## 1.0 APPLICATION SUMMARY

Request: Modify Street Type typical sections;  
Add a new Street Type;  
Change block boundaries

RE: PRS 22-0028

**Proposed Shopping Center Internal Drive:**

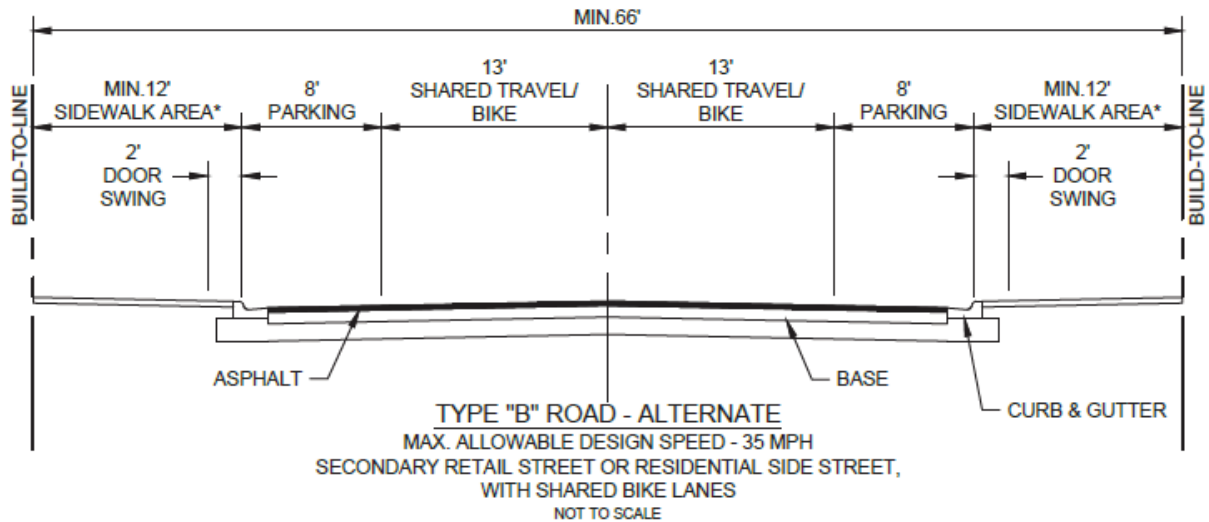
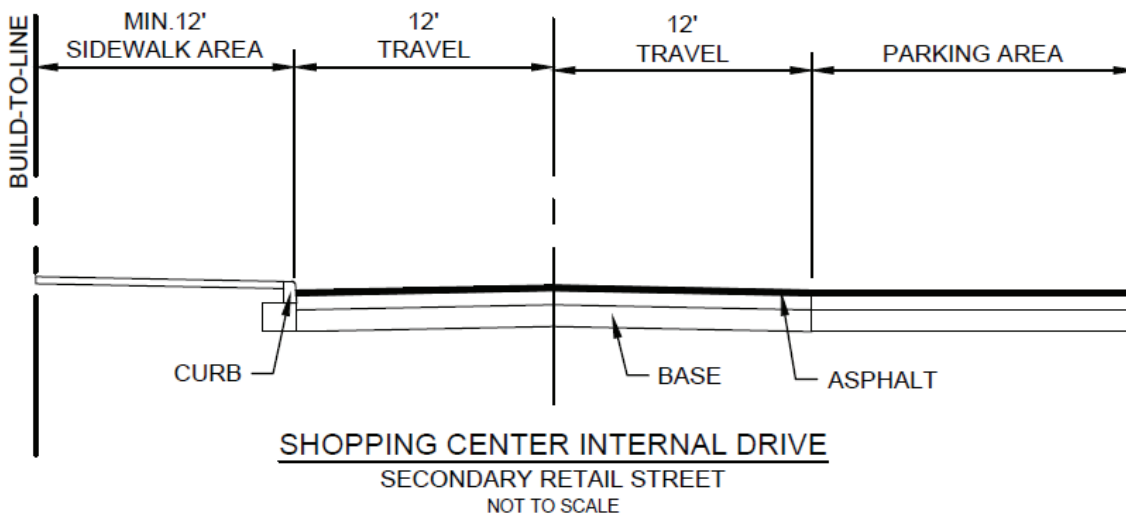
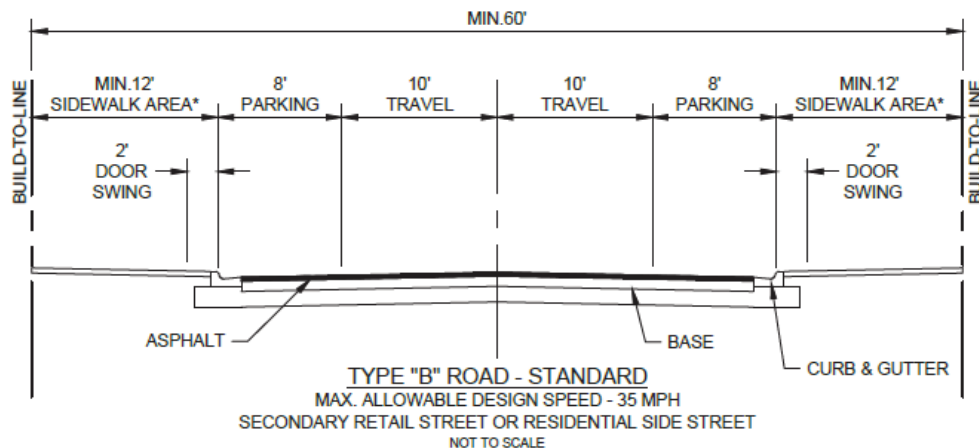
The PD GSP today requires the street between Blocks 10 and 14, as well as 9 and 13, to be designed as a Type B street. There are two Type B typical street sections approved today in the PD. "B" Streets are secondary retail streets or residential side streets (potentially including shared bike lanes).

Type B Streets are 60 to 66 feet wide, can accommodate sidewalks on both sides, street parking (parallel) and shared bike lanes. The proposed modification only provides a sidewalk on one side, adjacent to the retail buildings, and parking spaces are located on the opposite side. The total width has been reduced considerably. The design of this drive is typically found in shopping center surface parking lots.

Staff evaluated the modification of the Type B street and the applicant has proposed conditions requiring the timing for when the Shopping Center Drive would be re-built to the originally approved Type B typical sections. The proposed condition would establish two scenarios: *either (i.) portion of adjacent Blocks 9, 13, or 14 is further developed or redeveloped, and/or (ii.) further development or redevelopment of the retail area within Block 10. Additionally, the surface parking lot on Block 14 would be allowed to continue until it is redeveloped in accordance with the conditions and standards stipulated by the PD.*

#### Proposed Phase 1 Type D Street:

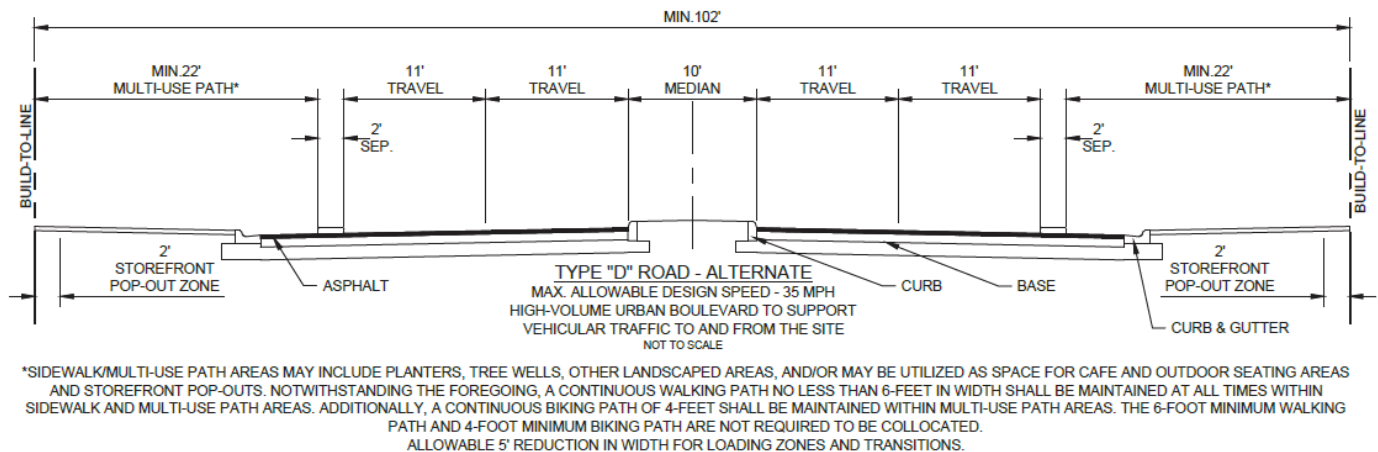
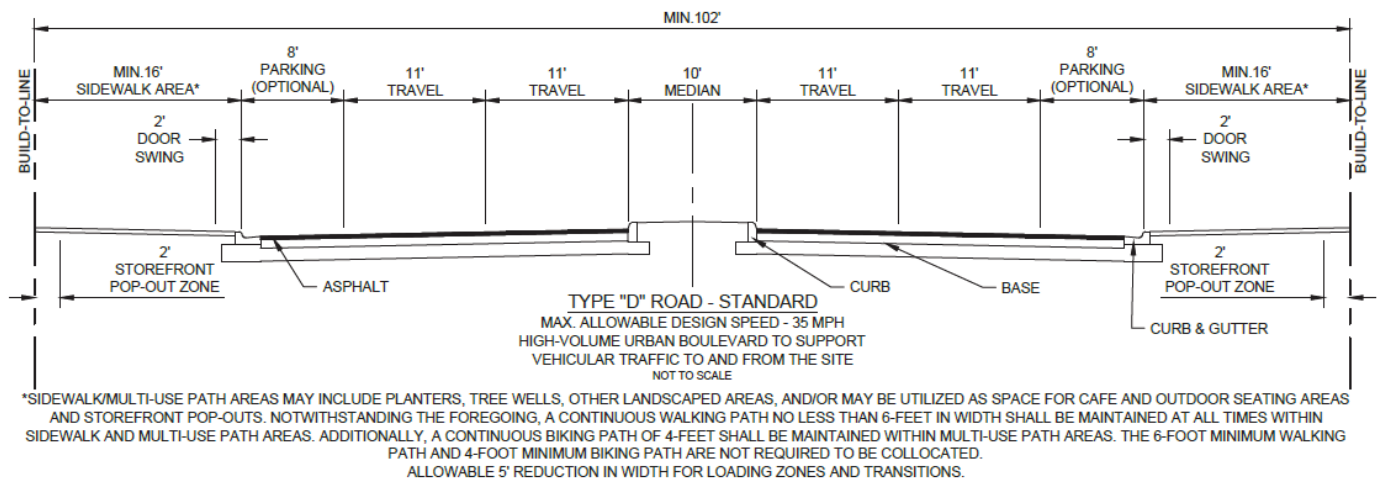
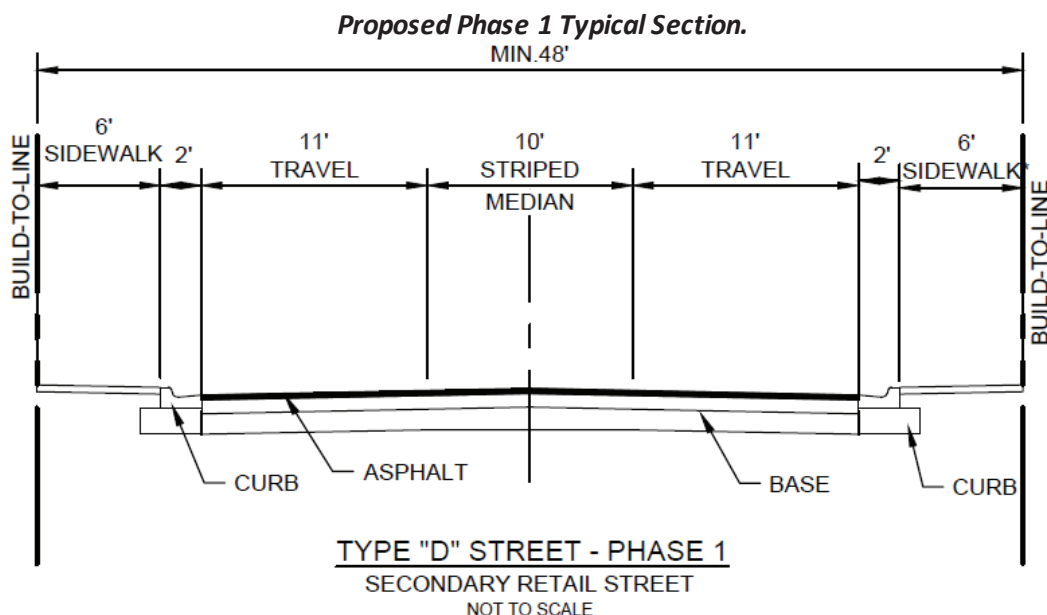
Currently, the PD provides for two Type D typical sections that connect three of the Property's existing access points to Fowler Avenue through the Project and through small portions within the City of Tampa's jurisdiction. According to the applicant, these three connections are constrained by existing uses with long-term leases and property owned by third parties. Therefore, development of the approved typical sections to Fowler Avenue are not viable in these locations (at this time) due to these constrained roadway widths.

According to the narrative, the developer will provide the required typical sections (as originally approved) when the intensity of the Project warrants the improvements as set forth in proposed conditions. In the interim, the applicant proposes a Type D Phase 1 typical section to be constructed concurrent with the development of the New Retail Area. This interim typical section will provide roadways and pedestrian connections to Fowler Avenue to serve the New Retail Area and the remainder of the Project. The New Retail Area will be approximately +/- 94,876 square feet. Therefore, the interim typical sections would provide ingress and egress capacity sufficient for existing and proposed uses into the foreseeable future. To demonstrate sufficient capacity, the applicant has provided a Traffic Monitoring Report prepared by Kimley-Horn dated December 20, 2021 to the County staff as part of this application.

The applicant is proposing to change the “Type B Street” in front of this retail area to a “Shopping Center Internal Drive,” which includes the following proposed cross-section:

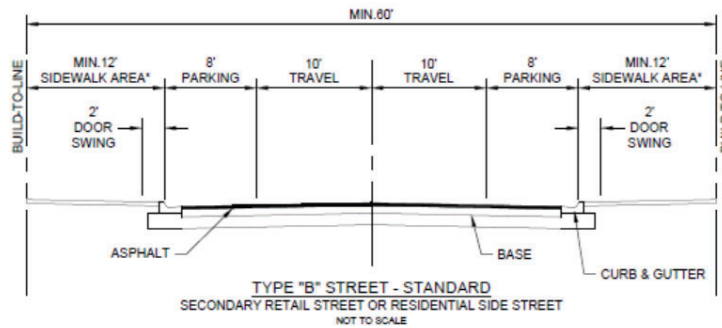
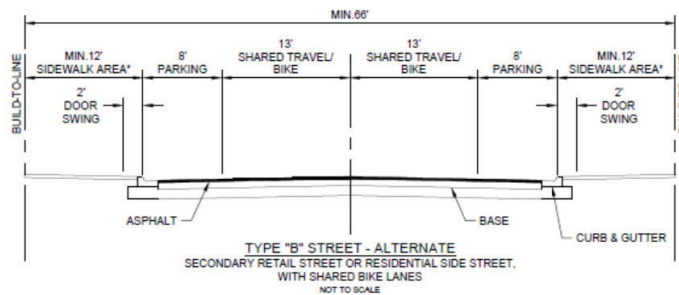
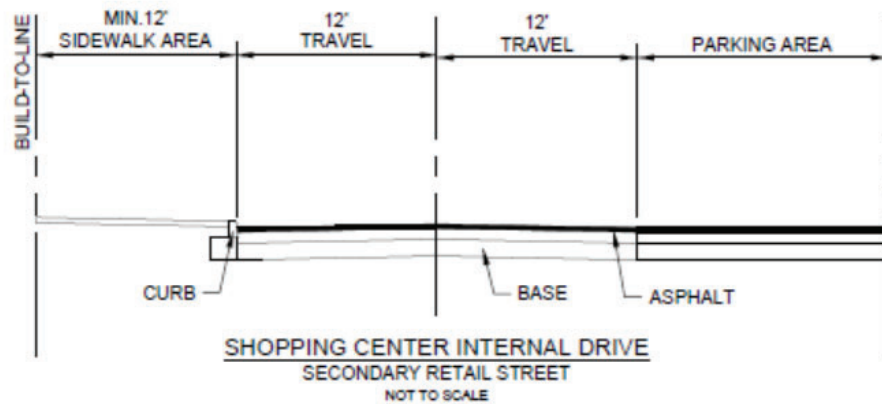
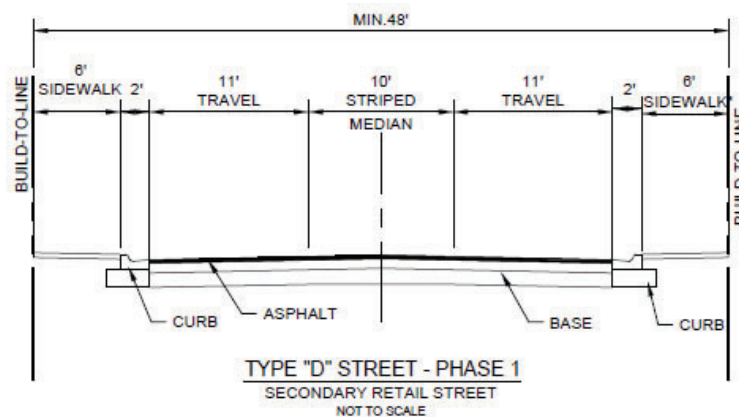
The request for PRS 22-0028 includes proposed modifications to the street type on the south side of Block 10 in front of the proposed Sprouts, Burlington, and Retail buildings, as shown here:

The original approval (PD 19-1443) showed this area as a “Type B Street.” The approved “Type B Street – Standard” cross-section is as follows:

The approved “Type B Street – Alternate” is as follows:

While the “Shopping Center Internal Drive” includes a minimum of 12 feet as a sidewalk area in front of the building, the cross-section shows the removal of the reciprocal 12-foot sidewalk on the other side of the cross-section. “Shopping Center Internal Drive” also eliminates the 8-foot on-street parking lanes shown on both sides of the travel lanes in both the “Type B Street – Standard” and the “Type B Street – Alternate” approved cross-sections. The proposed “Shopping Center Internal Drive” cross-section increases the two travel lanes from 10 feet to 12 feet each. The proposed changes are drastically different than the original approval by eliminating one side of the sidewalk, eliminating on-street parking, and increasing the travel lane widths. Overall, the proposed changes maintain the large surface parking areas that already accommodate automobile users and then removes amenities for pedestrians and bicyclists, resulting in safety concerns for multimodal users.

The applicant is also proposing to add a “Type D Street – Phase 1” cross-section, which is shown as follows:

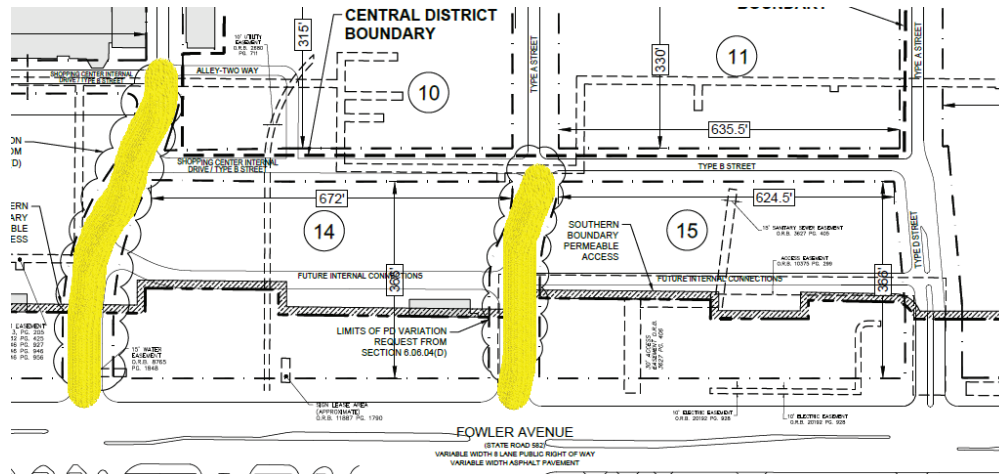
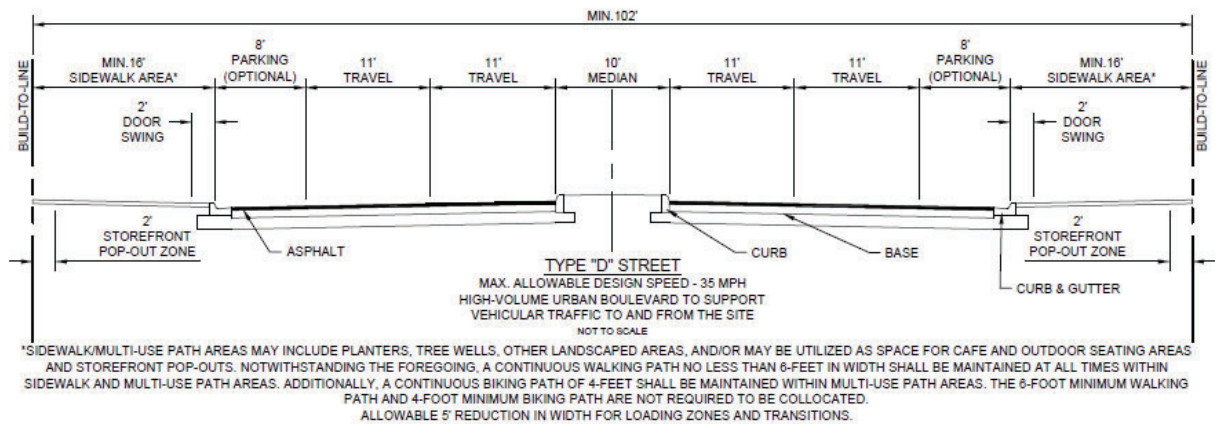
The “Type D Street – Phase 1” cross-section is proposed for two of the entrances to the site, as shown below.

The approved “Type D Street” is as follows:

As shown above, the new proposed “Type D Street – Phase 1” proposes to eliminate the two 16-foot sidewalk areas, replacing them with a 6-foot sidewalk on both sides of the street. In addition, the optional on-street parking has been removed from the cross-section, the 10-foot raised median has been replaced with an at-grade 10-foot striped median, and the number of travel lanes has been reduced from two in each direction to one in each direction.
